Amendment of AC 29-2C

Proposal for Amendment of AC 29-2C

Proposed changes to AC 29-2C

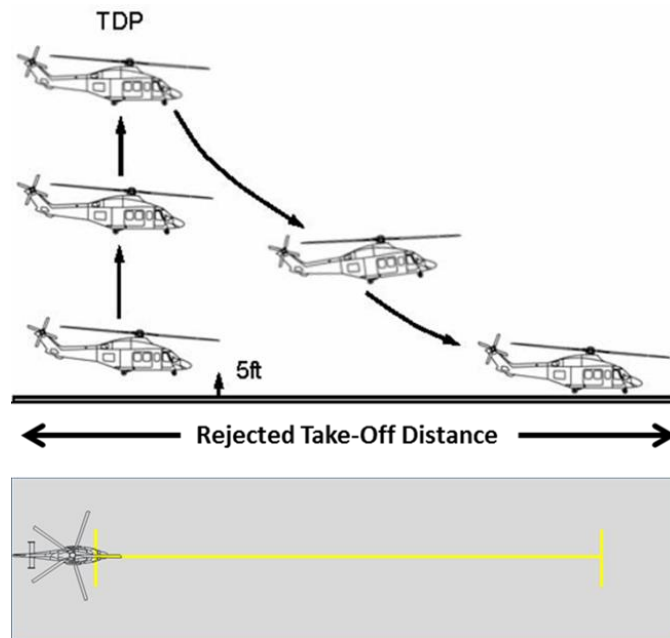
2. Whilst there is adequate advice for the vertical takeoff which includes a run-on (as shown in the diagram below) in the current advisory material in AC 29.59 paragraph b (12)(iv)(A):

“...Establish the rejected takeoff distance as the horizontal distance from the rearmost point of the rotorcraft at the initiation of takeoff to the foremost point after the rotorcraft comes to a stop on the takeoff surface (including rotor tip path), assuming an engine failure in the vertical climb at the TDP.”

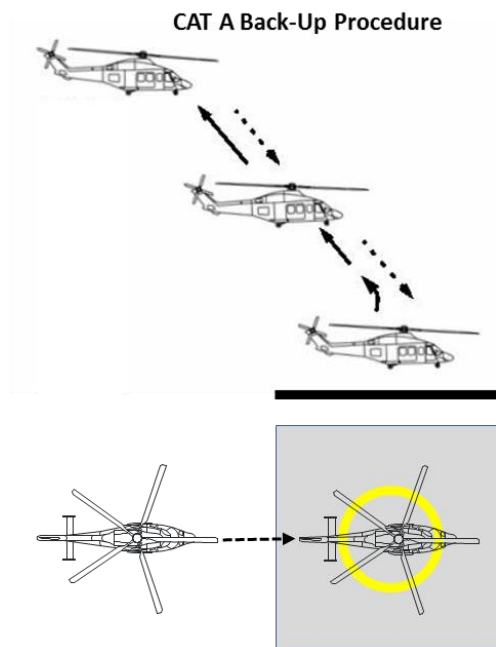
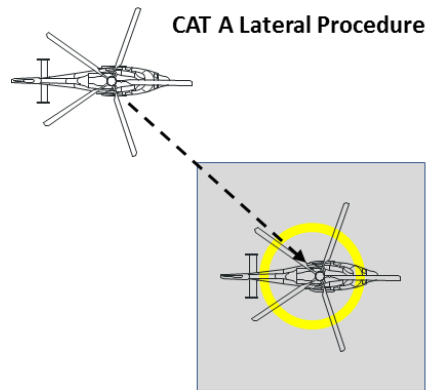
Additional clarity is required to enable applicants to establish the appropriate RTOD for vertical procedures when they are part of a back-up or lateral procedure (both shown below):

In these two cases it might clearer if the existing wording in AC 29.59A paragraph b (12)(iv)(A):

...Establish the rejected takeoff distance as the horizontal distance from the rearmost point of the rotorcraft at the initiation of takeoff to the foremost point after the rotorcraft comes to a stop on the takeoff surface (including rotor tip path), assuming an engine failure in the vertical climb at the TDP.

was augmented with an appropriate wording more suited to the conduct of the helipad procedure - based upon the wording in AC 29.59A paragraph a (3):

For helipad procedures:

...Establish the rejected takeoff distance as the minimum area into which a rejected takeoff can be carried out, assuming an engine failure in the vertical climb to the TDP. This area should provide containment of all elements of the rotorcraft.

Figure H-1 – S76 showing the absolute minimum undercarriage containment area

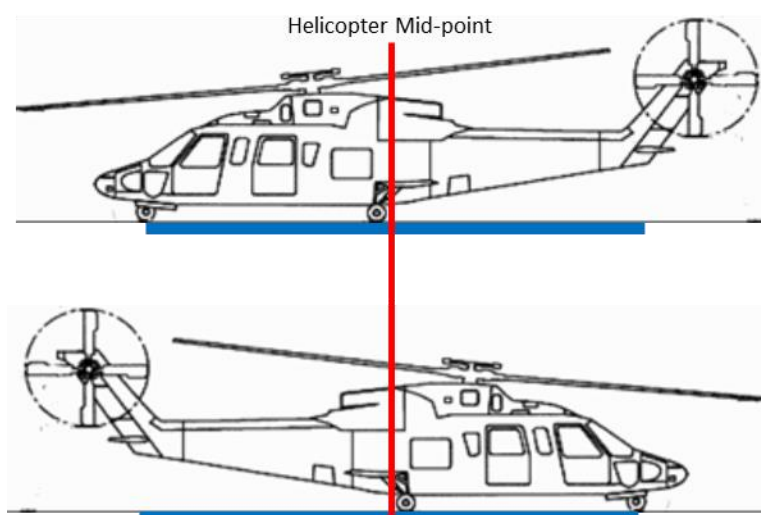
The data arising from the landing scatter must also take account of undercarriage configuration. With a ‘helipad’ procedure³, this will require that landings in all directions be taken into consideration in the provision of the minimum size. As can be seen from [Figure H-1](#), the S76 has an undercarriage that is completely ahead of the mid-point of the helicopter; this will result in an absolute minimum undercarriage containment area of $0.63D$. To this must be applied the landing scatter - applicable in a 360° context, before adding the dimensions of the helicopter. It is expected that the minimum size will be expressed as a circle with a diameter that provides the necessary helicopter containment.

It would appear that, for a number of years, manufacturers have declared, in the flight manual, a ‘minimum elevated heliport size demonstrated’ that is not directly associated with helicopter containment. From discussions, it has been established that this dimension is that required only for containment of the undercarriage⁴ and the provision of adequate visual cues.
